Agenda
Planning Commission
Council Chambers
Wednesday, 19 April 2017 – 7:00 P.M.

COMPLETE STREETS REVIEW

Courtesy review of 2017 Road Program including portions of Summit, Congress, and Hamilton.

Subject: Hamilton mill & overlay, Cross to Washtenaw, complete streets courtesy review

LOCATIONS OF DETAIL
NW & SW CORNERS OF
HAMILTON & EMMET

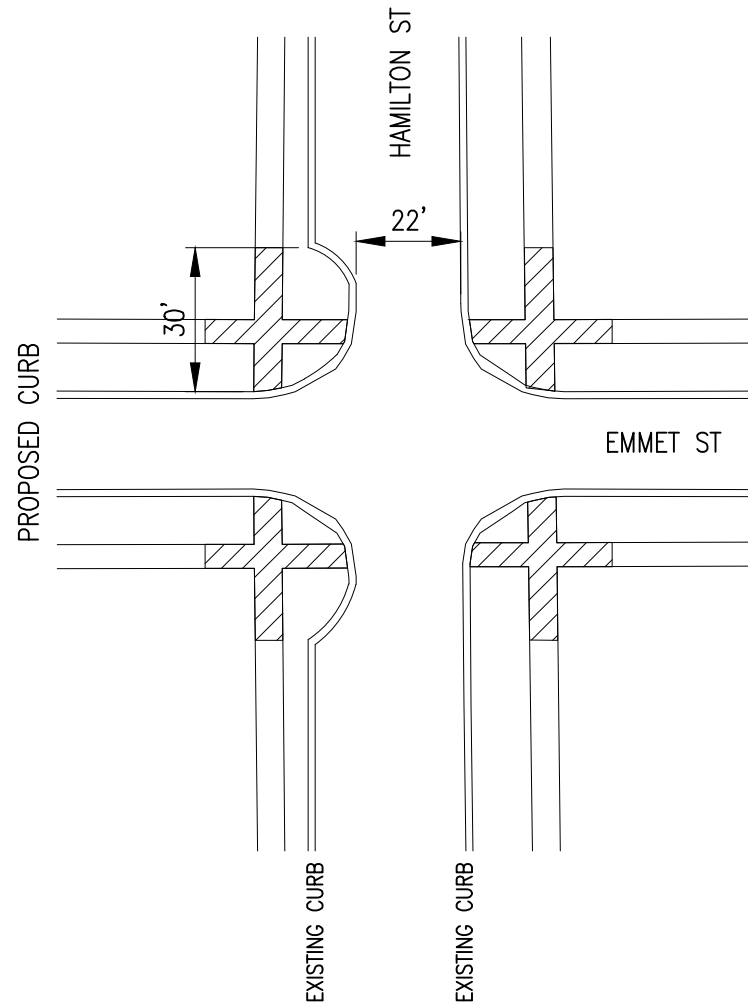
Currently, the City DPS & Engineers are proposing the addition of bumpouts on the west side of the street at the intersection with Emmet. There are no bumpouts proposed for Cross or changes at Washtenaw; note that both locations border or include MDOT right-of-way. Additional, bike-friendly signage is proposed but unspecified; planning staff suggests “Bikes May Use Full Lane” at Cross and Washtenaw.

LOCATIONS OF DETAIL
NW & NE CORNERS OF
CONGRESS & NORMAL
CONGRESS & ELM

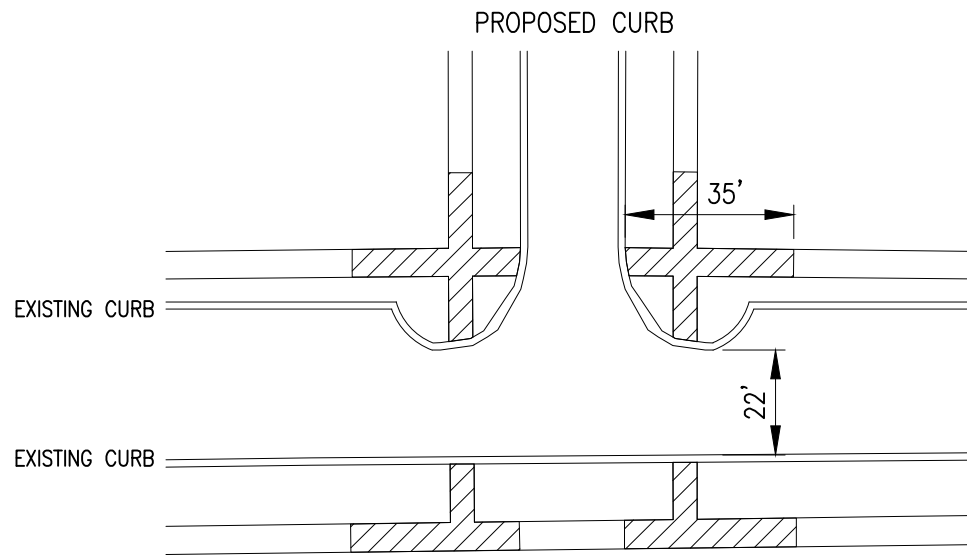
Currently, the City DPS & Engineers are proposing the addition of bumpouts on the north side of the street at the intersections with Elm and Normal. There are no bumpouts proposed for Summit, or changes at Ballard. Additional, bike-friendly signage is proposed but unspecified; planning staff suggests “Bikes May Use Full Lane” at Summit and Ballard.

LOCATIONS OF DETAIL
NE & SE CORNERS OF
WOODS & SUMMIT

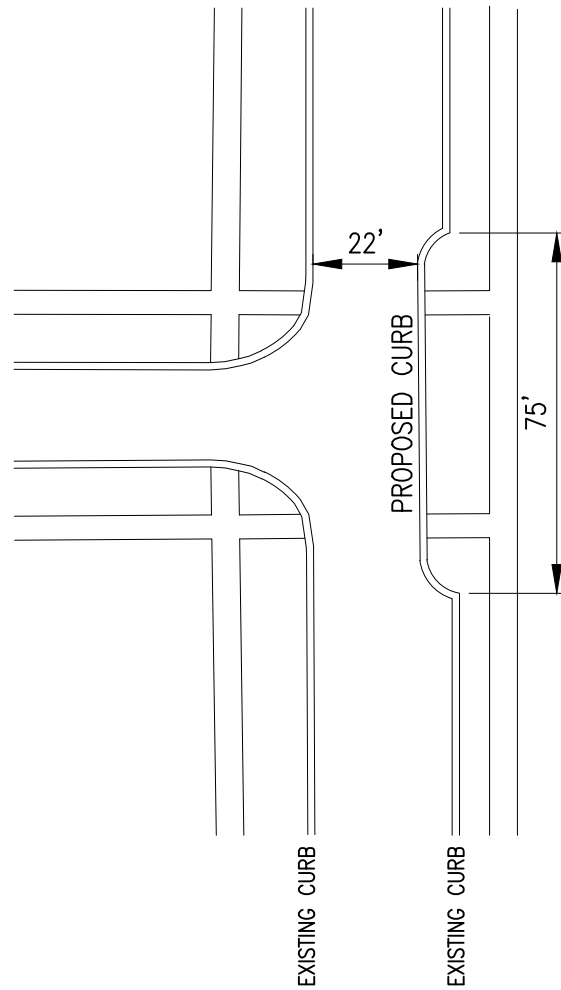
Currently, the City DPS & Engineers are proposing the addition of bumpouts on the east side of the street at the intersections with Sheridan, Grant, and Woods. There are no bumpouts proposed for Pearl, Congress, or Michigan. Additional, bike-friendly signage is proposed but unspecified; planning staff suggests “Bikes May Use Full Lane” at Michigan, Congress, and Washtenaw.

Figure 1- North side, west entrance

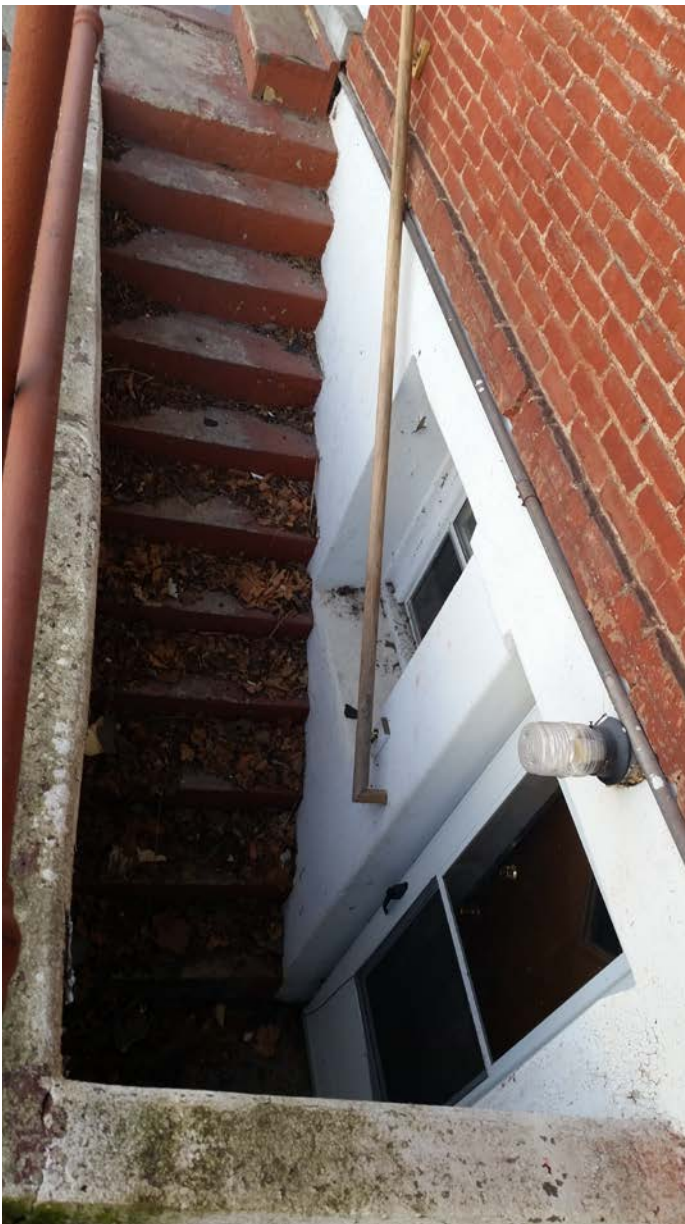
There are two "main" entrances on the N Washington St side; one in the three story portion and one in the single story portion. There are two entrances in the rear of the property and another two on the north side, only one (the northern of the rear entrances) appears to be an entrance that can access more than one unit.

1. Provide barrier-free entry to buildings from parking areas.
2. Applicant to make the following changes to the southern lot:
 - a. Narrow existing drive; it is significantly wider than the drive apron.
